ADDITIONS & ALTERATIONS TO:
OLD GREENWICH SCHOOL
285 Sound Beach Avenue
Old Greenwich, CT 06870
STATE PROJECT # 057-0115 EA/RR/CV

PROJECT MANUAL
BIDDING AND CONTRACT REQUIREMENTS
INVITATION TO BID #03
May 15, 2025

ADDITION & ALTERATIONS TO: OLD GREENWICH SCHOOL
FOR THE TOWN OF GREENWICH
STAE PROJECT NO. 057-0115 EA/RR/CV
MAY 15, 2025

Date: 11/22/2024
Scale: As indicated
Drawn By: JM
Project Number: 22-382
Drawing Number: A132

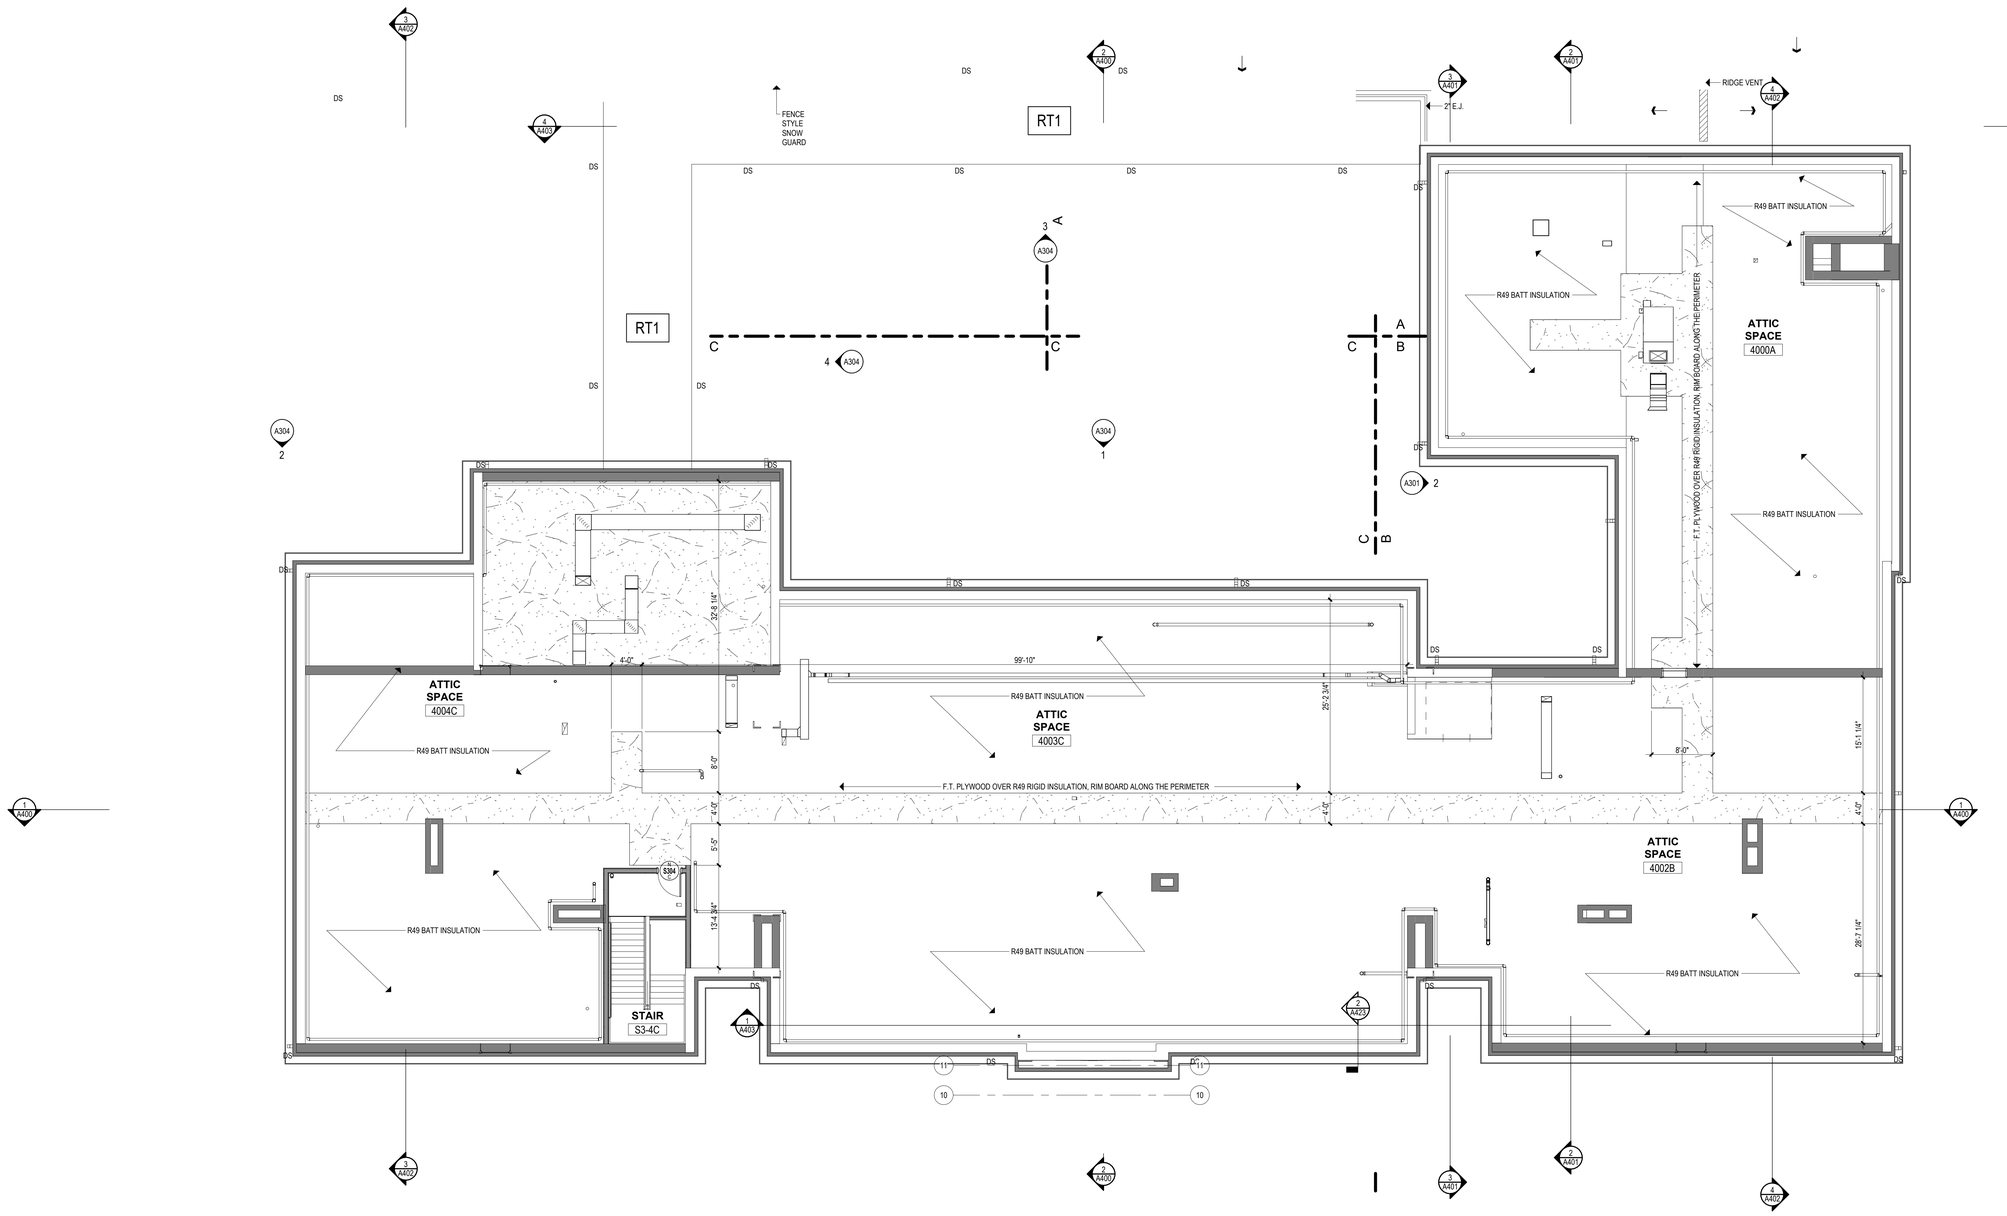
- **RFI #121** **Question:** New lockers counts and locations - Drawing A132 does not call out detail 8/A803 for the corridor lockers. Confirm that detail 8/803 is not intended at these lockers.
  Response: Locker details on Drawing A803 are for refurbished lockers as indicated on floor plans.

- **RFI #123** **Question:** New lockers counts and locations - Drawing A132 shows many lockers in the same location as the demolition plan, meaning they do not move. Since these lockers are not moving, do these get refurbished?
  Response: Refer to RFI #64.

- **RFI #124** **Question:** New lockers counts and locations - Drawing A132 shows some banks of lockers differently versus the demolition plan but without the N tag. Please clarify this.
  Response: Refer to RFI #64.

Response: Access ladder to be non-insulated as specified.
- **RFI #125** **Question:** New lockers counts and locations - Drawing A132 - How are the existing finished left and right ends to be addressed on modified existing banks?

Response: Finished end panel by locker manufacturer.
- **RFI #126** **Question:** New lockers counts and locations - Drawing A132 - How are the sloped tops to be extended or cut on modified existing banks?

Response: Finished slope top end by locker manufacturer. Refer to RFI #127.
- **RFI #127** **Question:** New lockers counts and locations - Drawing A132 - How is the metal to be extended or cut on modified existing banks?
